RECORD OF BRIEFING

SYDNEY WESTERN CITY PLANNING PANEL

PPSSWC-148 – Campbelltown City Council – 4079/2017/DA-CD – 183 Narellan Road, Campbelltown – Concept application for the staged development of residential and open space land uses including stage 1 for earthworks and superlot subdivision, stage 2 for civil works, and stage 3 for residential subdivision

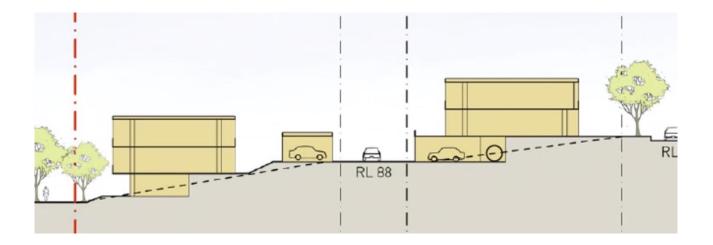
With attention to the eastern more dense end of the site, the Panel will stand to be convinced that narrow lots down to 140 m2 with 16 square metres of private open space located over a garage is suitable for this location, which does not benefit from a town centre location. This image is provided for reference.
